ADDRESS: 502 WOOD ST

Proposal: Construct six-story multi-family residential apartment building

Review Requested: Review and Comment

Staff Contact: Megan Cross Schmitt, megan.schmitt@phila.gov

EXTERIOR ELEVATIONS

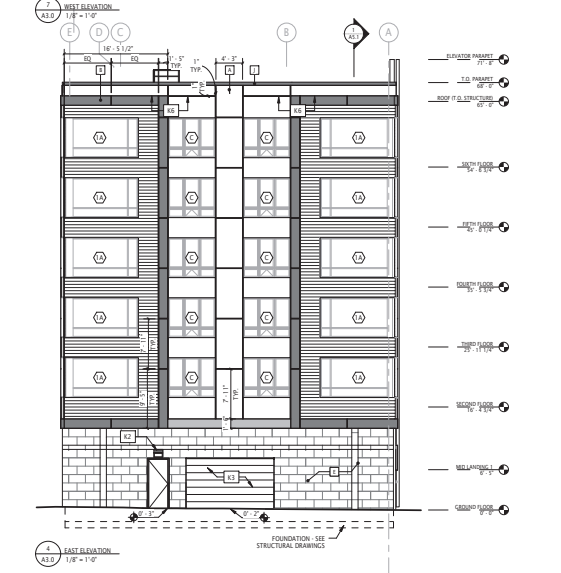
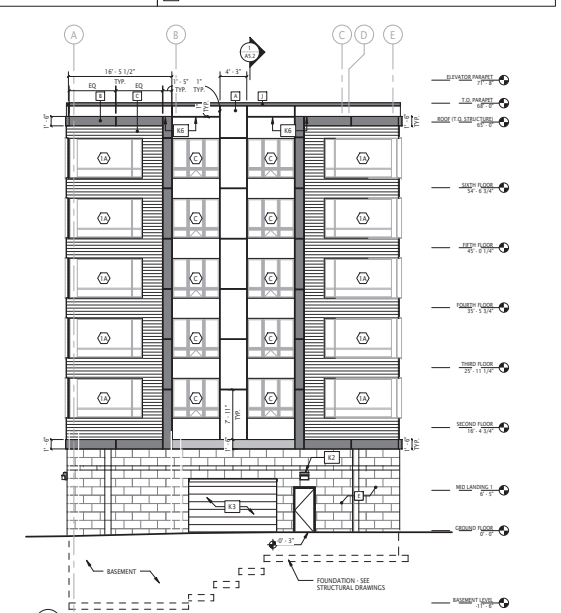
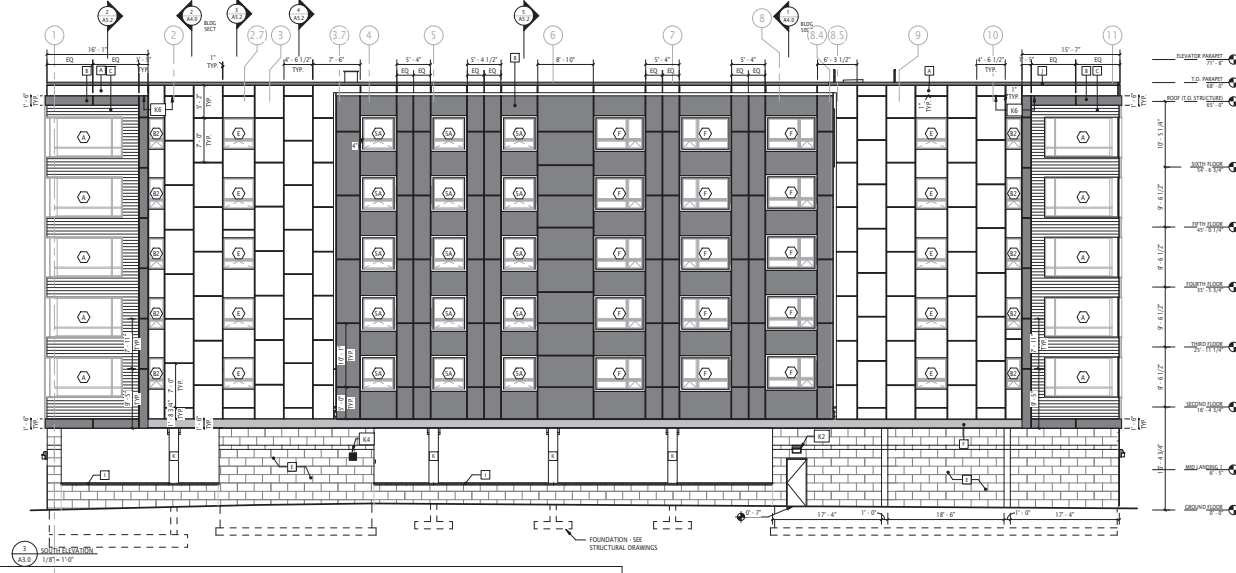
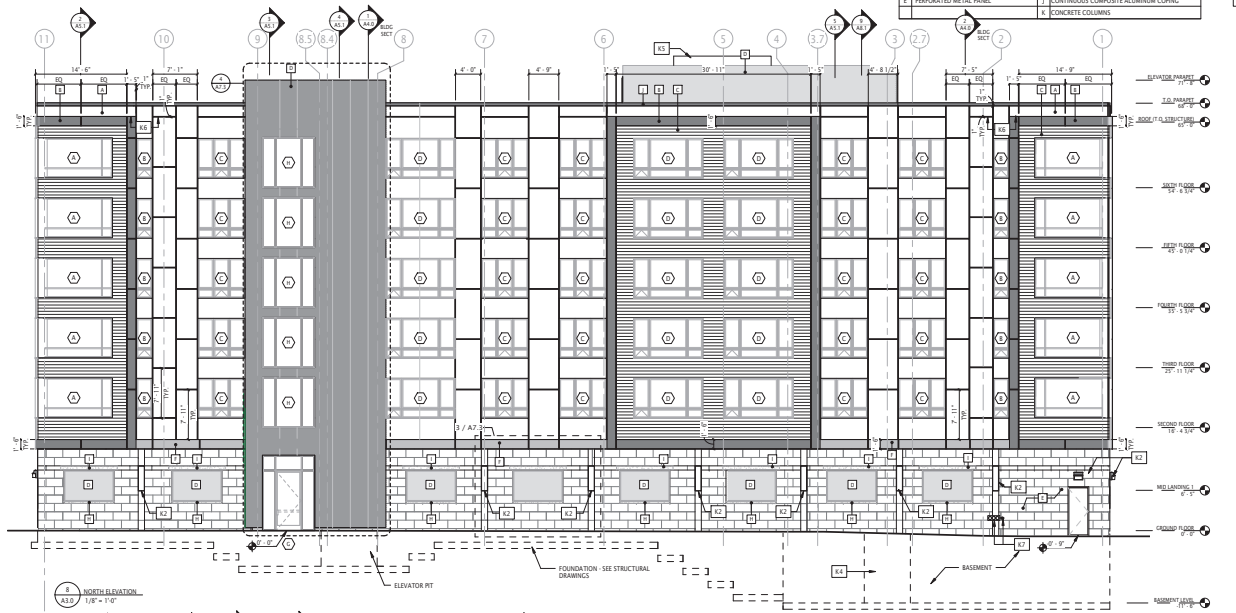
- The design of this building does not relate to the context of the Old City Historic District. The building is to be clad in metal panels of various shades of grey and one described as having a "wood look."

- The materials and rhythm of the fenestration do not appear to reference any of the architecture seen within the Old City Historic District. In this regard, the design is differentiated from the historic fabric, however it fails to achieve the compatibility that is required by this standard.

STAFF COMMENT: The proposed new construction is not compatible with the historic district and does not satisfy Standard 9.
